ADDENDUM No. 2

Project Name: **Pinckney Park Pavilion**

Project Number: 19019

Date: 06/06/2019

ELECTRICAL POWER & LIGHTING PLAN

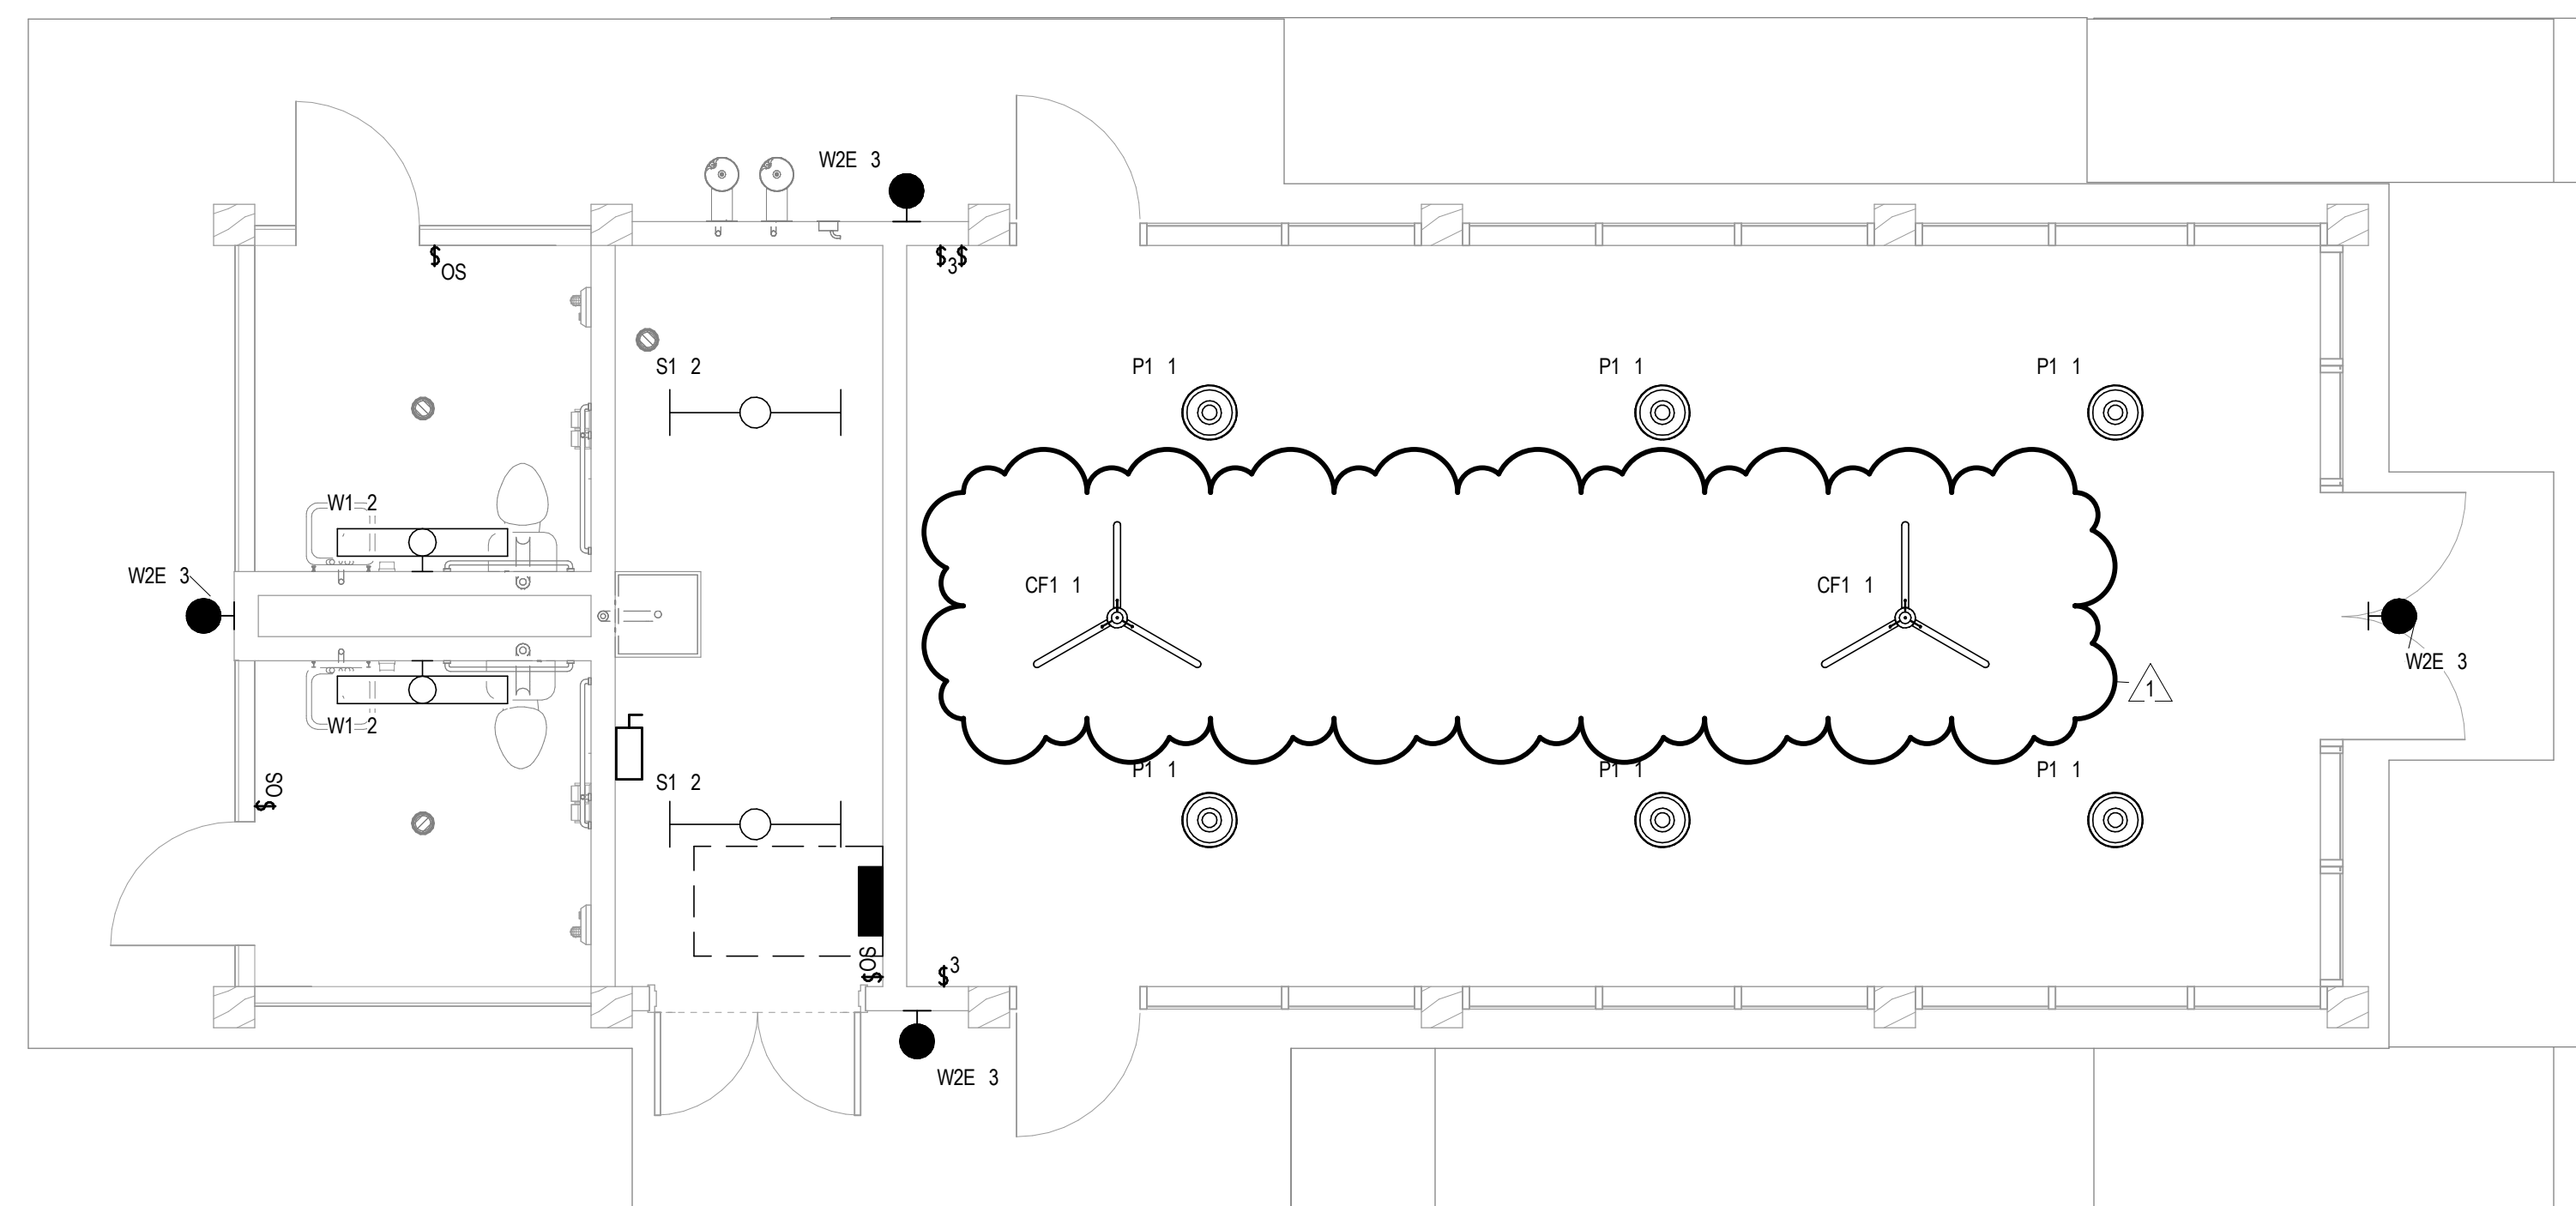
E101 – Replace sheet in its entirety (see attached)

ELECTRICAL ONE-LINE DIAGRAM & SCHEDULES

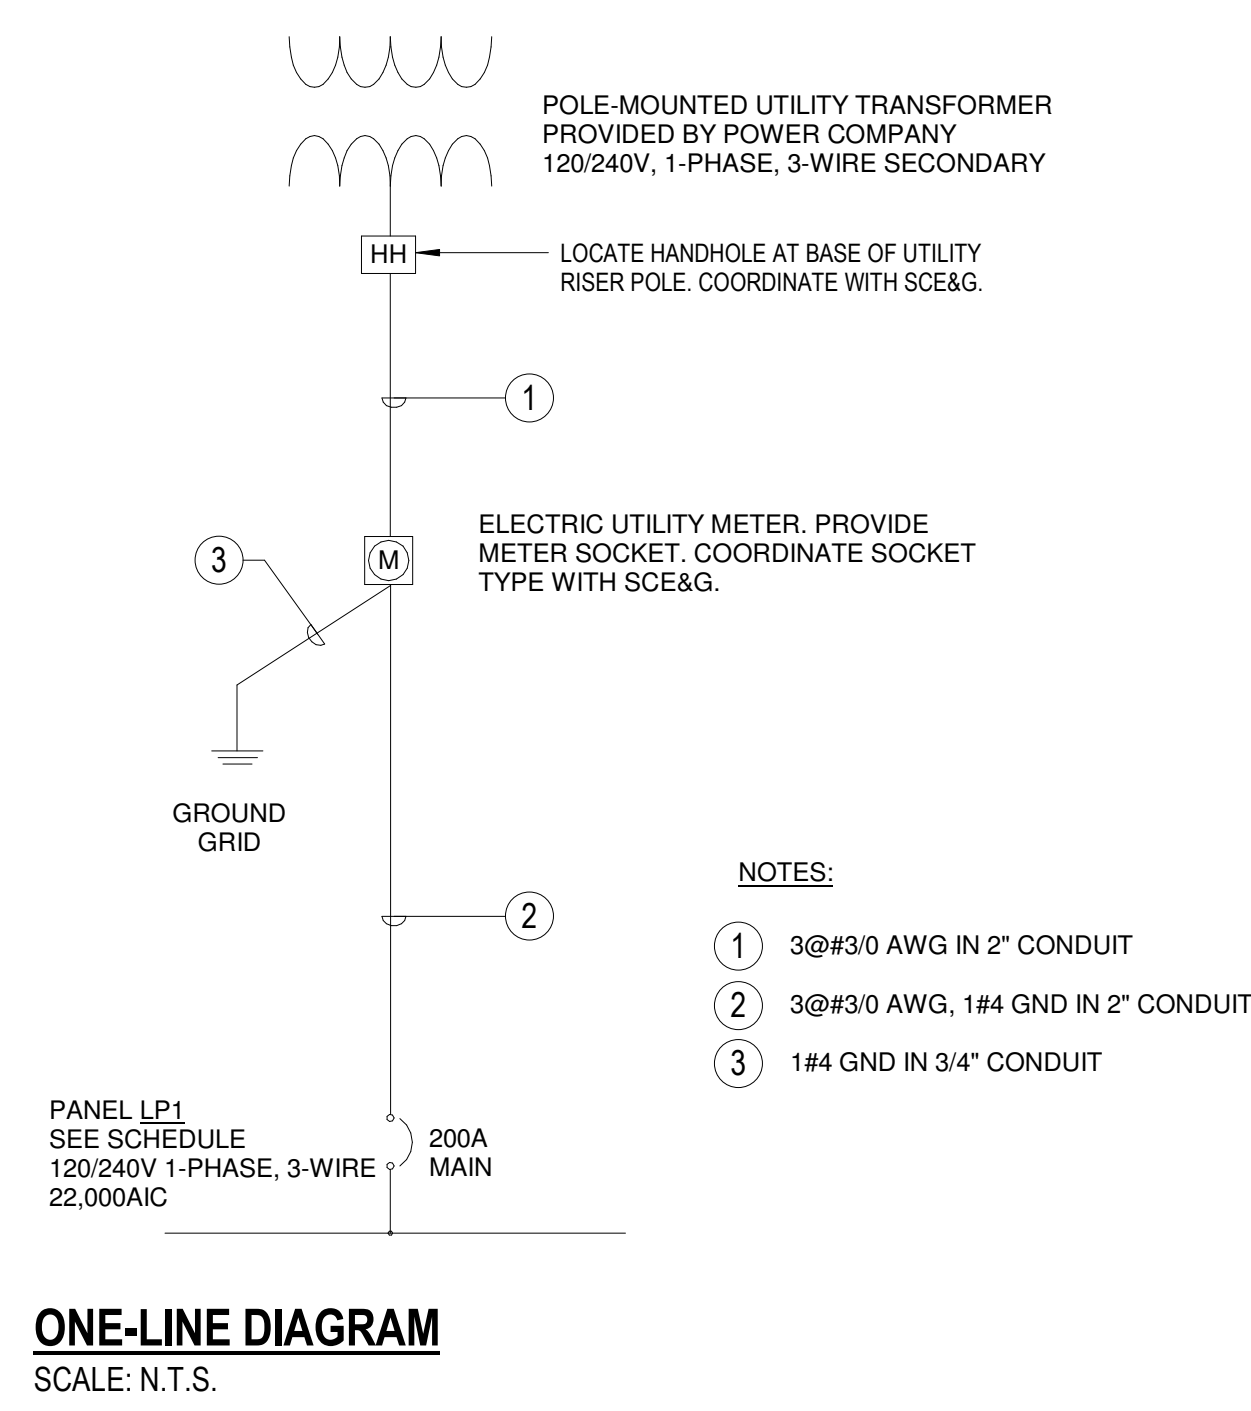
E201 – Replace sheet in its entirety (see attached)
